## **Twin Waters West Sunshine Coast Queensland EPBC referral by Stockland Pty Ltd.**

STOCKLAND DEVELOPMENT PTY LIMITED of 133 Castlereagh Street SYDNEY NEW SOUTH WALES 2200 has made a submission to EPBC in relation to its proposed development at Twin Waters West.

OSCAR maintains that the assessments set out in Stockland’s own referral actually demonstrate the opposite and that their application **should** be declared a Controlled Action.

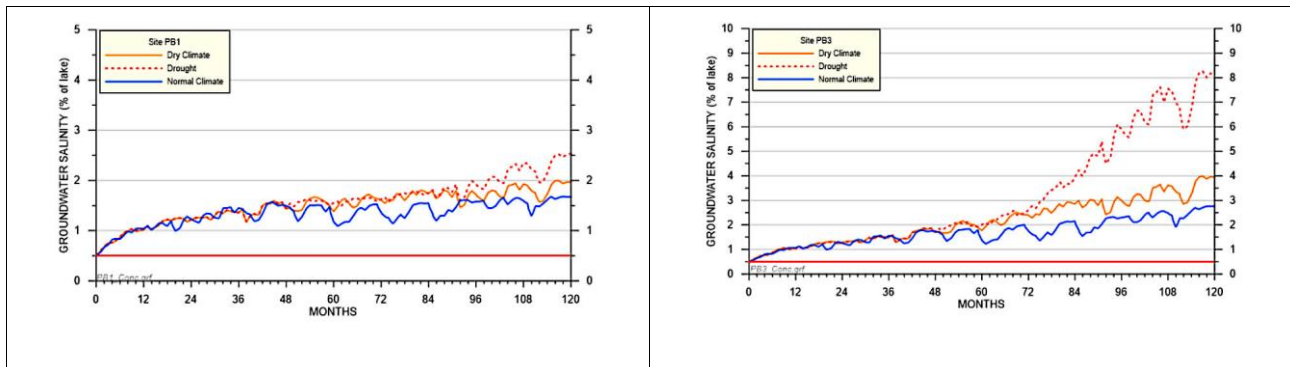
Modelling<sup>7</sup> indicates that the curtain is not expected to be fully successful with steady increases in salinity expected in wet periods with further increases during dry periods especially when introducing recycled water (Figures 17 to 19 of Attachment 19). Extracts of their Figure 17 and 19 are reproduced below.

These figures were described by the author of Attachment 19 as demonstrating that salinity “gradually increases with time from its initial concentration of 0.5%, substantially stabilising after 10 years”. The figures demonstrate a 3 to 16 fold increase in salinity above current background salinity after 10 years. To TWWS, the figures appear to demonstrate little stabilisation after 10 years with an upward annual trend in all cases. The worst trend modelled indicated groundwater salinity at 8% of seawater and increasing after 10 years.

The ecologists stated in Attachment 3 Appendix I that the increases exhibited by the above modelling were expected to be within natural variation. No data however was presented to demonstrate that the groundwater salinity varies by this amount naturally. In fact the annual variations about a trend line reported in Figures 17 to 19 would be more likely to represent natural variation and this variation is less than the trends themselves.

We are disappointed at the “loose” interpretations of the above model results and are of the opinion that the model demonstrates ongoing deteriorating condition under all scenarios at all sites.

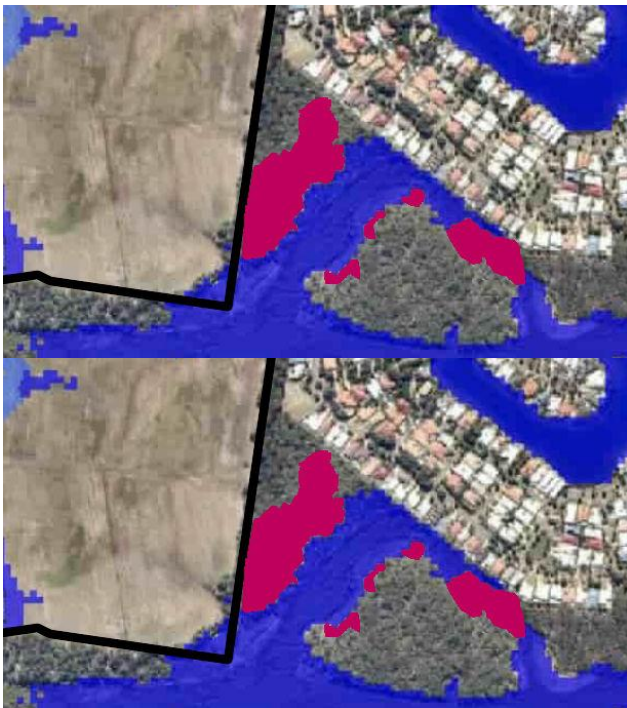
While the central wetlands are proposed to be quarantined from saline overflow of the CWB, the MRCP is not. Instead an eastern weir is proposed discharging directly into the MRCP. This weir low point is at the same elevation as that of the southern weir and as such will commence to overflow at the same time as the engineered south weir. The central wetlands had to be protected from saline flows from the CWB up to the 10% AEP flood, No such protection has been afforded the MRCP.

Saline alkaline water is expected to enter the MRCP early in a flood event with salinity decreasing progressively.

Location of land (light red) that would otherwise be dry will be flooded after a 1% AEP storm event

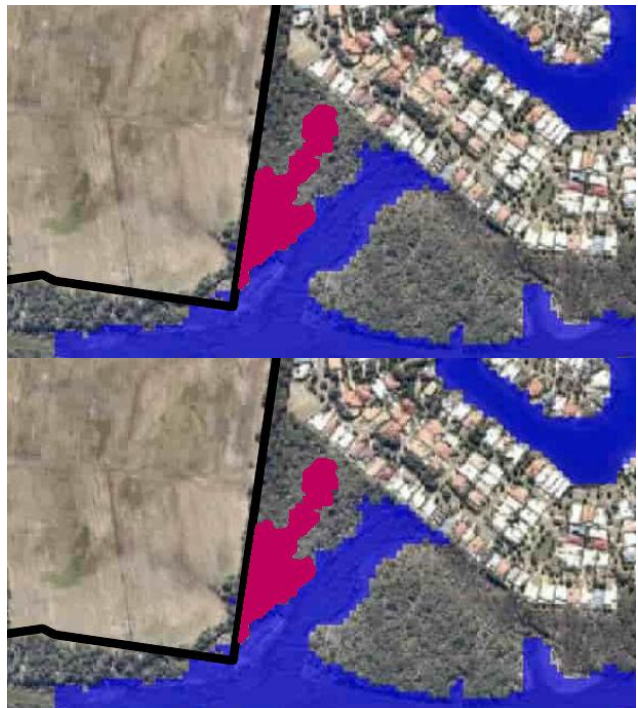
As a result of the weir to the MRCP, significant areas of land in the park that do not currently flood even at the 1% AEP storm event are to be inundated after development. Flood modelling results for the 10% and 1% AEP storm events are shown in the figures below. The maximum depth in these previously dry areas is over 0.5 m representing a significant increase in flood level in the park to areas that would otherwise be dry refuge areas.

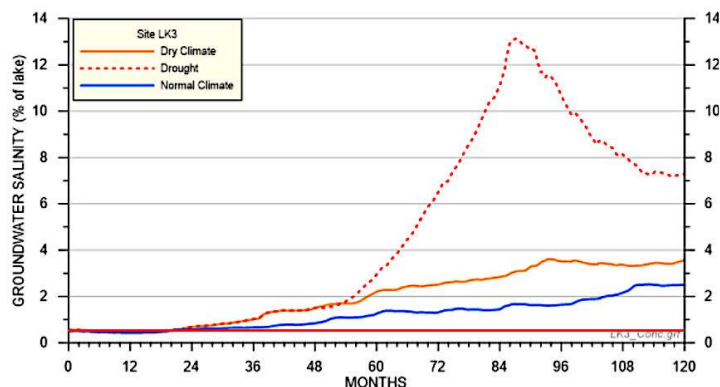
Modelling reports that velocities in some parts of the flooded area are to exceed 0.5 m/s. Velocities may exceed the scour velocities of 0.6 m/s as reported in the 2019 Flood Study. If this excess water concentrates in any drainage channel or flow path, accelerated flows may initiate or worsen erosion.
